Revised Final Agenda

TBPOC MEETING
October 3, 2013, 10:00am – 1:00pm
325 Burma Road, Oakland CA
TBPOC-PMT pre-briefing: 10:00am – 11:00am
TBPOC meeting: 11:00am – 1:00pm

RE: Agenda No. - 3a1

Pier E2 Shear Key S1 & S2 Anchorage Update

PIER E2 PLAN VIEW

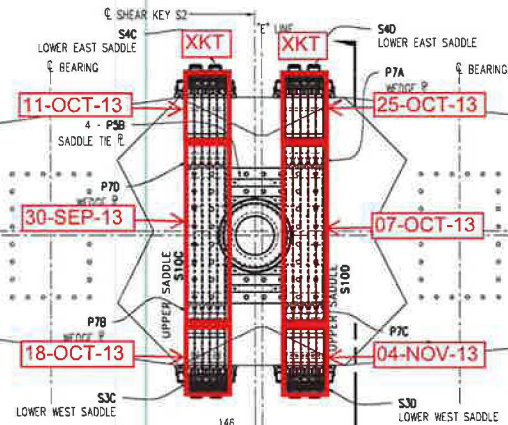
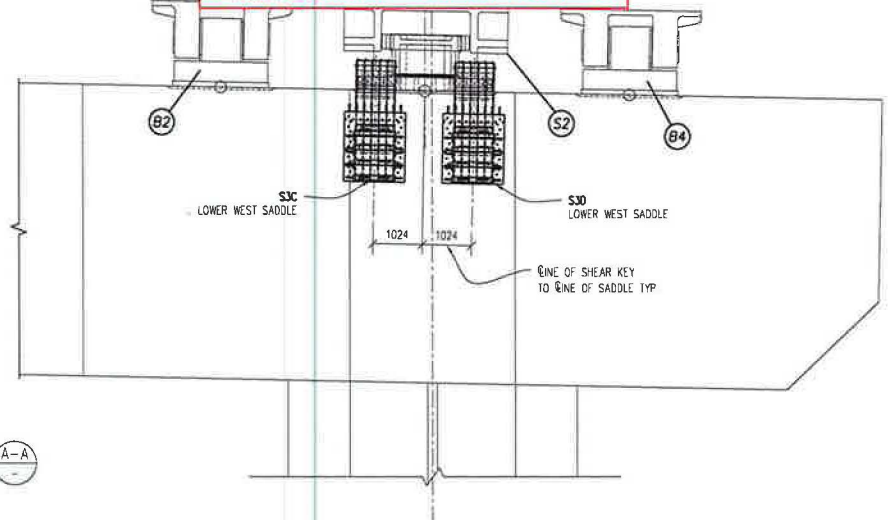
E2 SADDLE UPDATED DELIVERY DATES WITH MODIFIED ARRANGEMENT
(DATES SHOWN ARE SUPPLIER REVISED DATES)

**START W LINE WALL
CONSTRUCTION 07-OCT-13**

**START E LINE WALL
CONSTRUCTION 05-NOV-13**

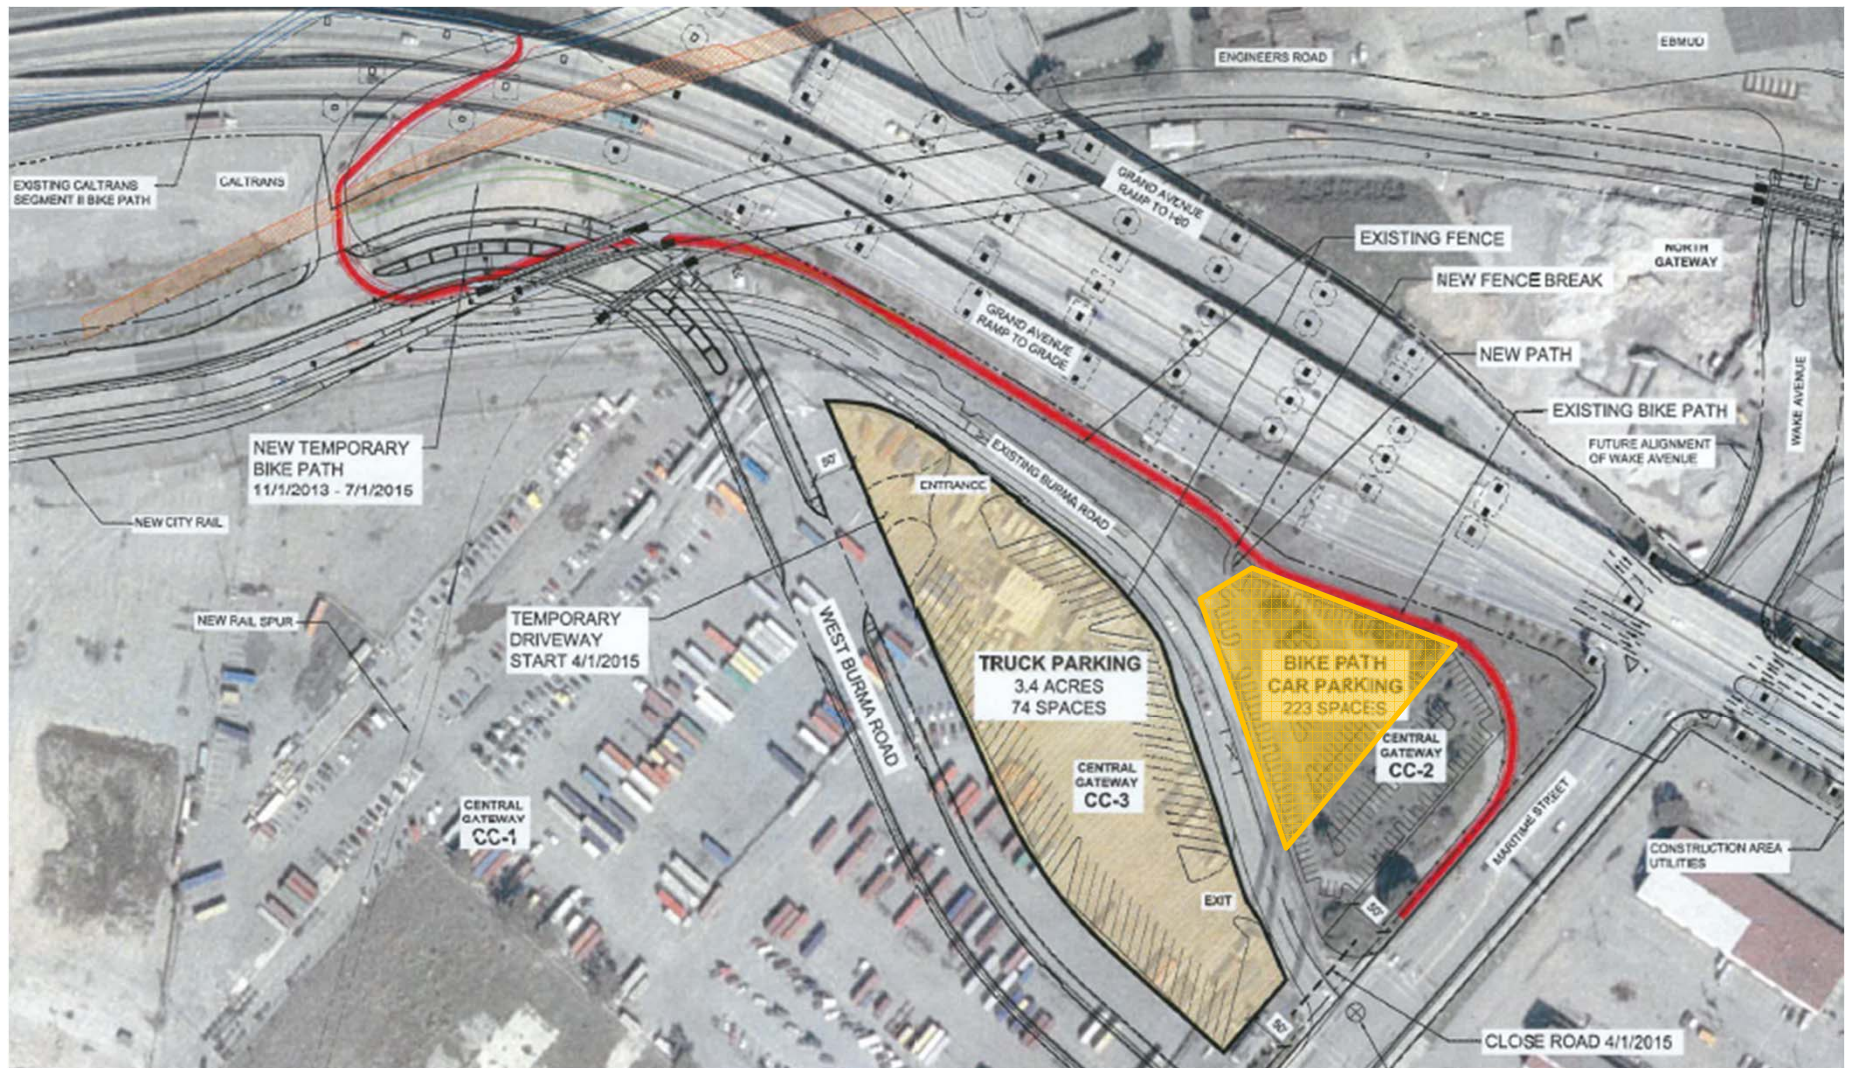
The City of Oakland will pave, fence and stripe the area in orange (the “pork chop”)

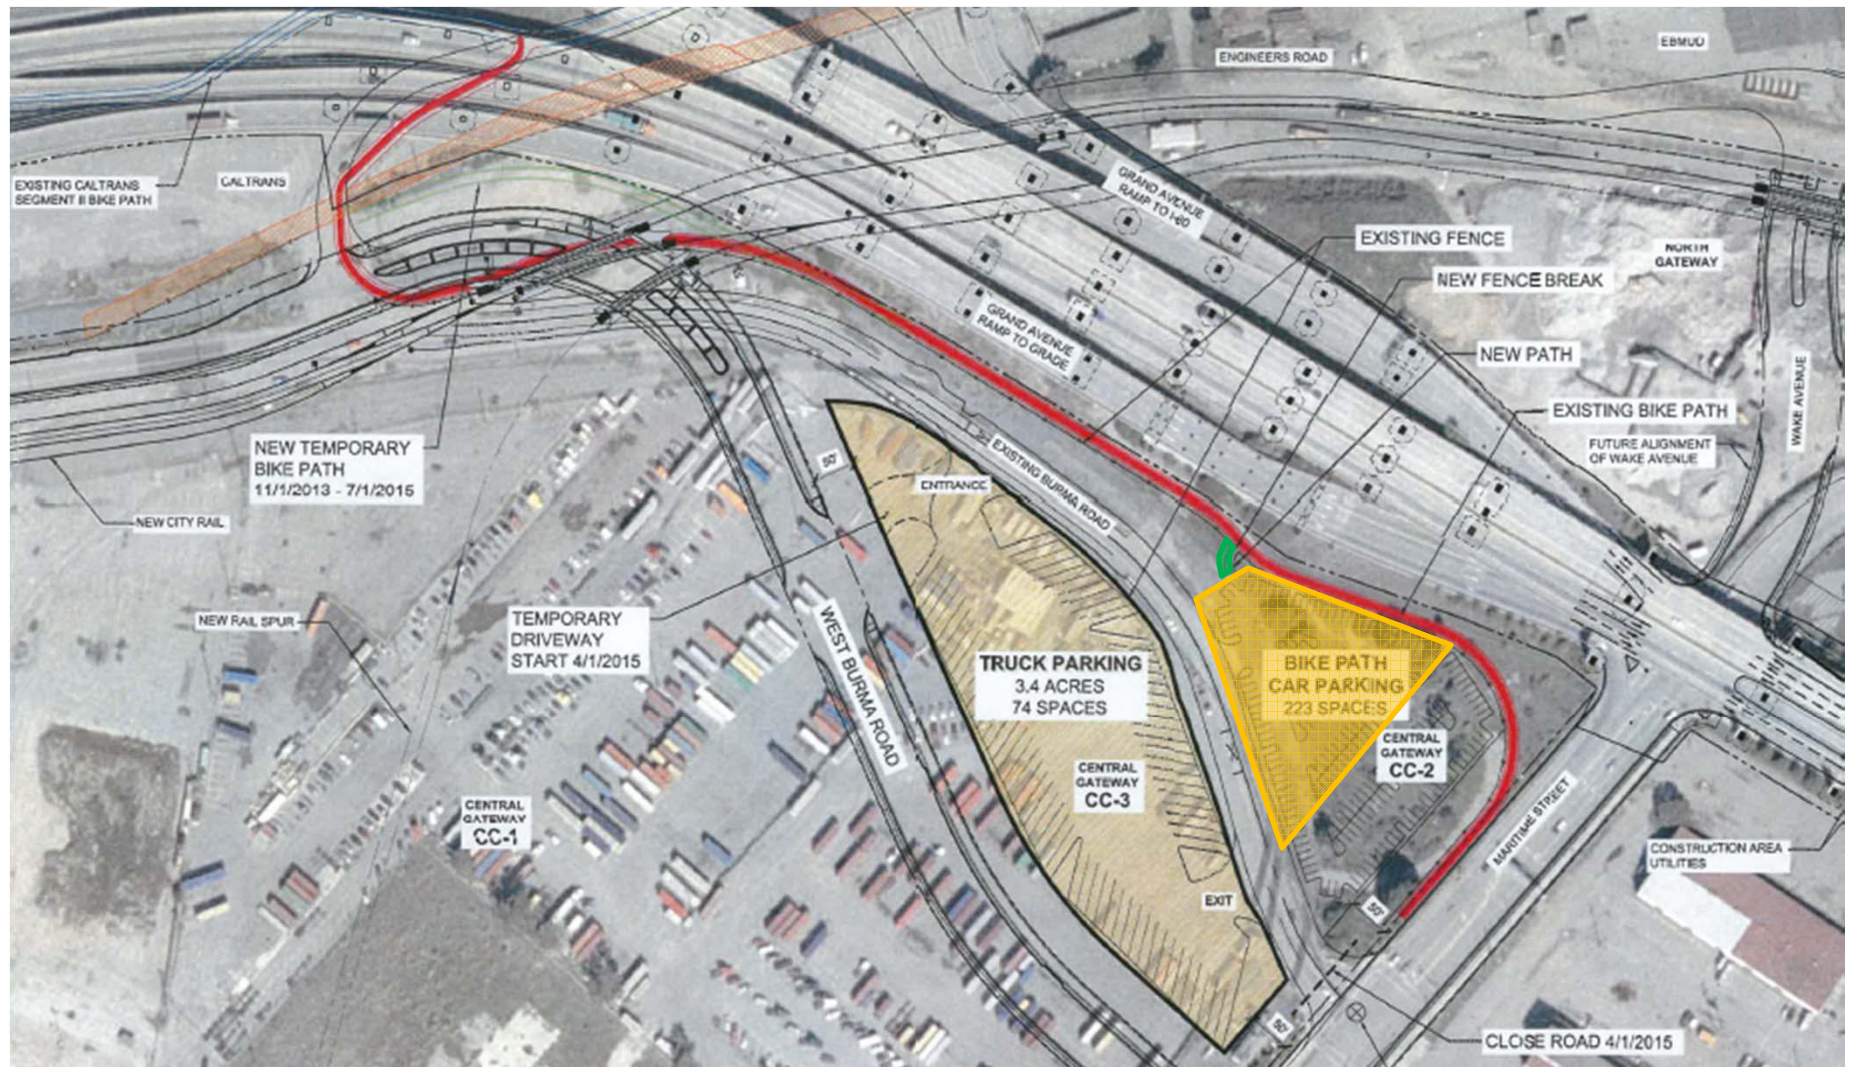
The Department will lease slightly more than half of the “pork chop” for bicycle/pedestrian path parking. There will be approximately 120 spaces.

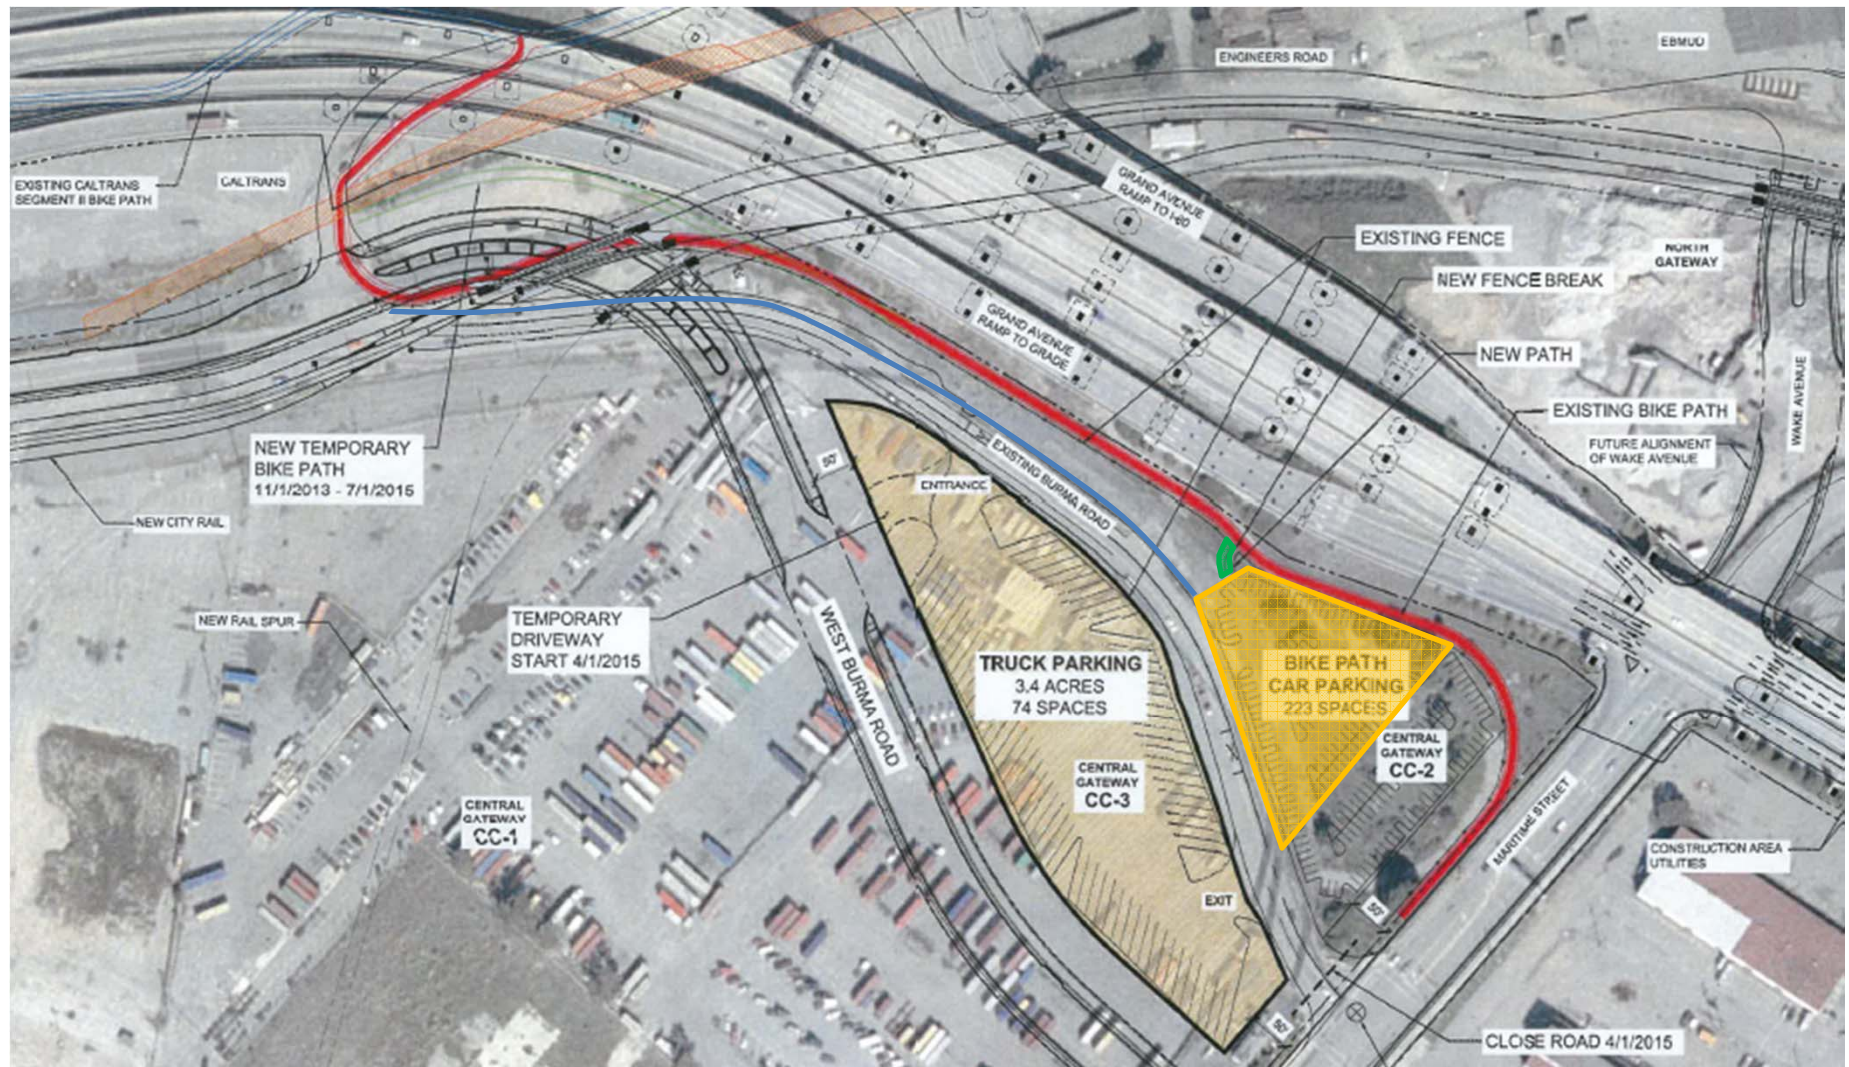
A new entry to the Segment 3 path will be created between the parking area and the path (shown in green). This entry is already in place.

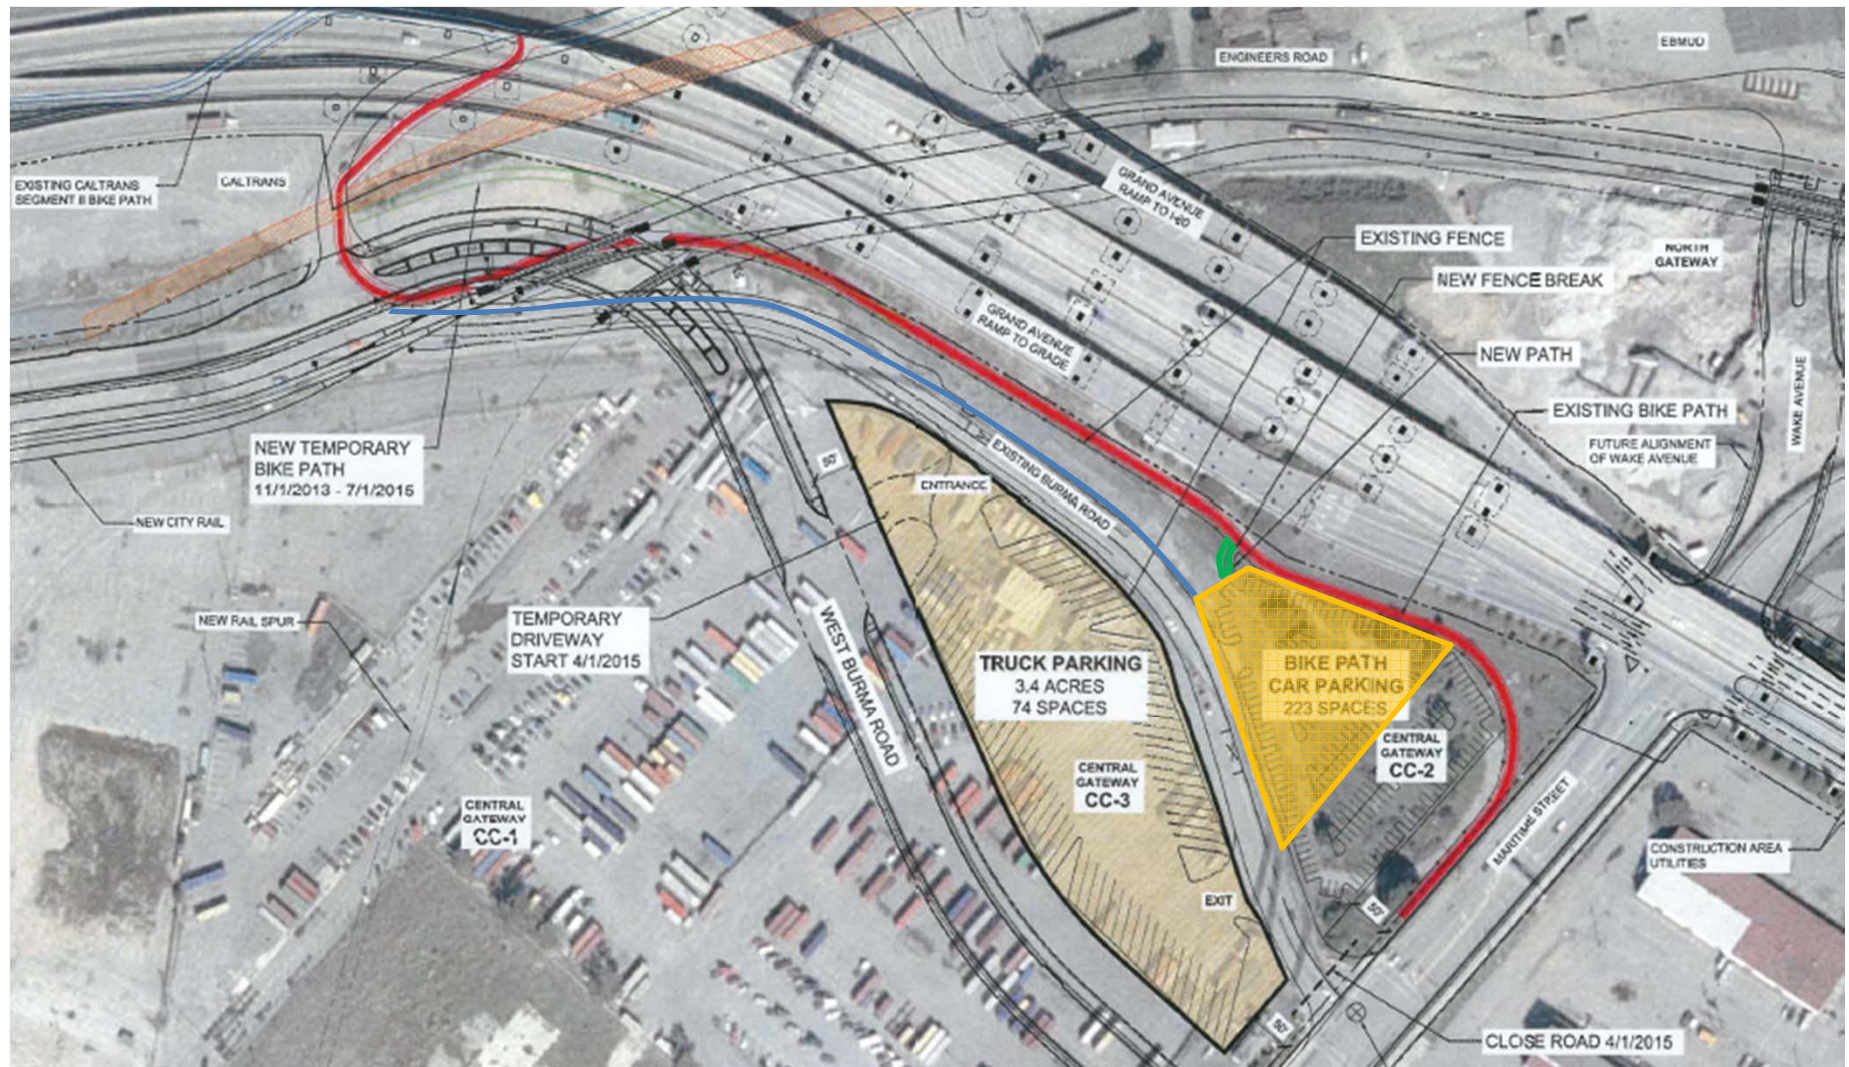
The City of Oakland will put up a fence at the edge of pavement on Burma Road to prevent parking along Burma (shown in blue).

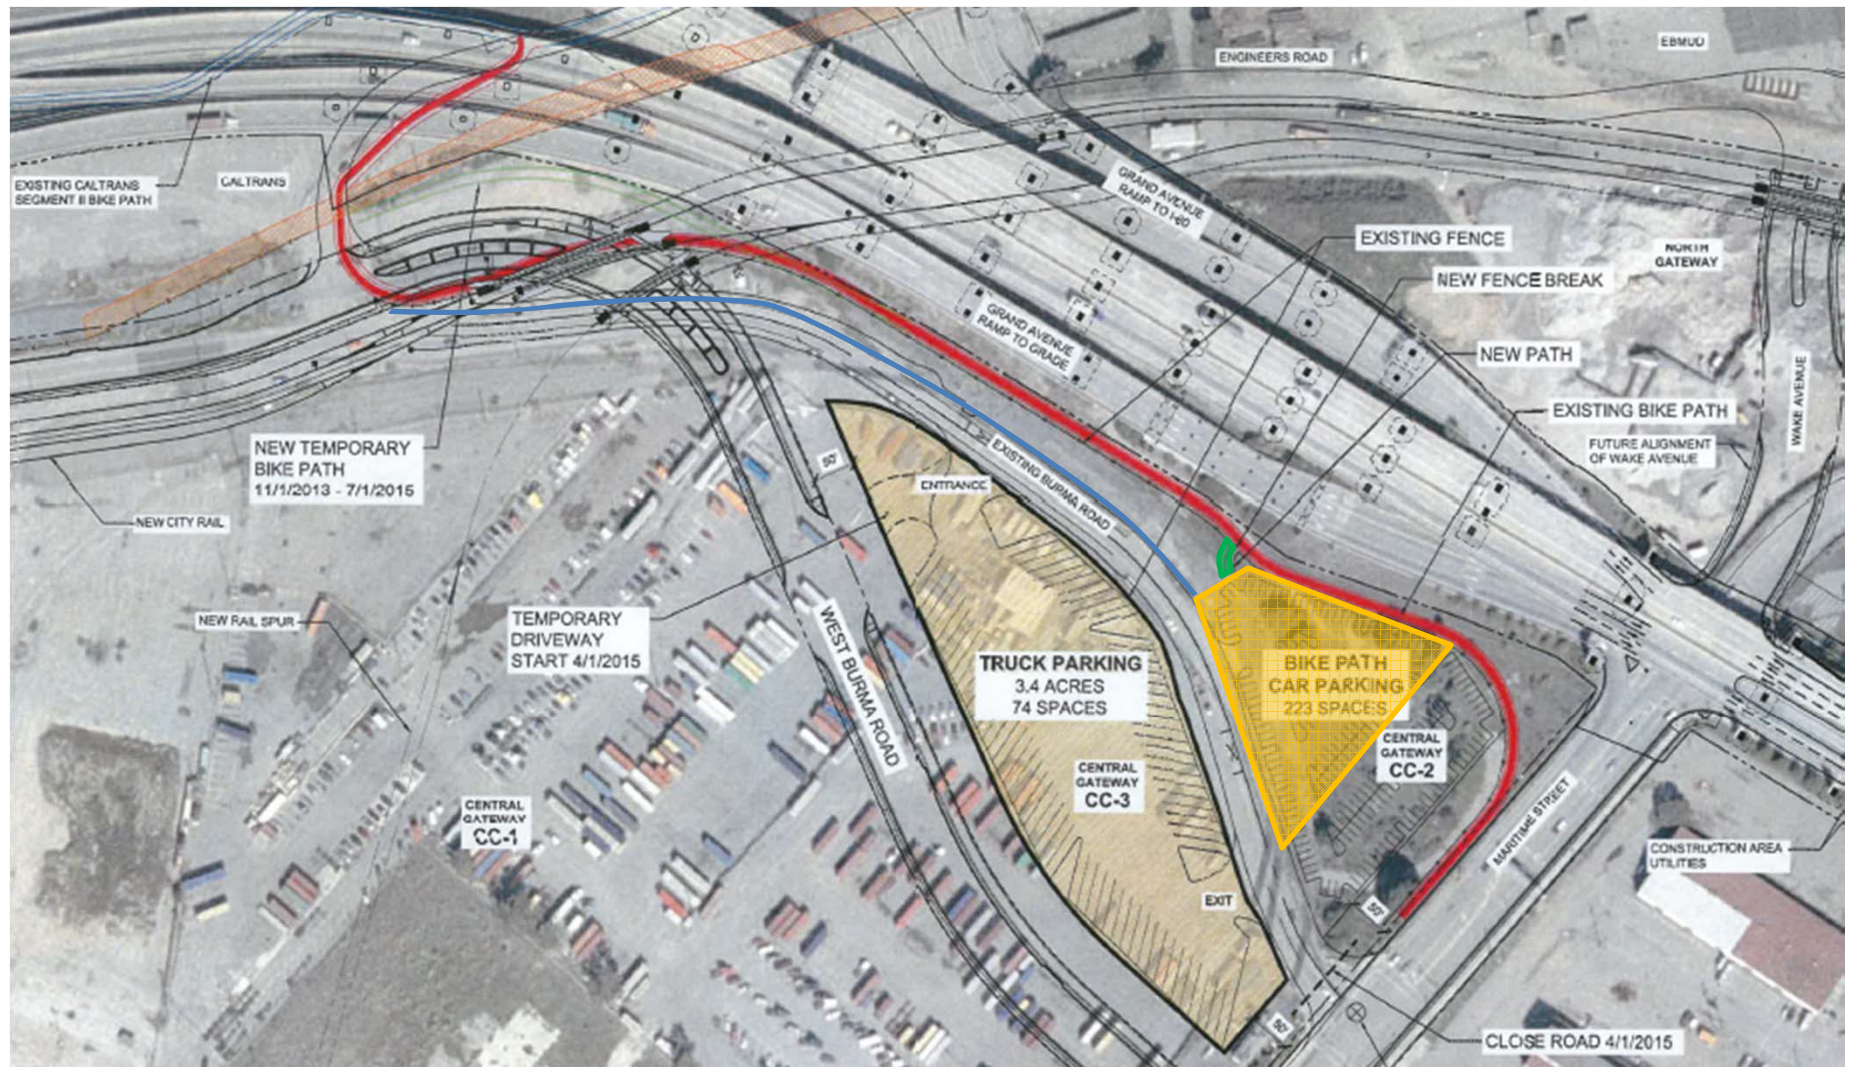
The City of Oakland will be responsible for security of the path parking lot. The lot will close approximately 1 hour after the path closes. Parking will be limited to 3 hours (it is currently limited to 2 hours in the dirt area). Construction of the lot should begin within the next 1-2 weeks and should take 3 weeks to complete.
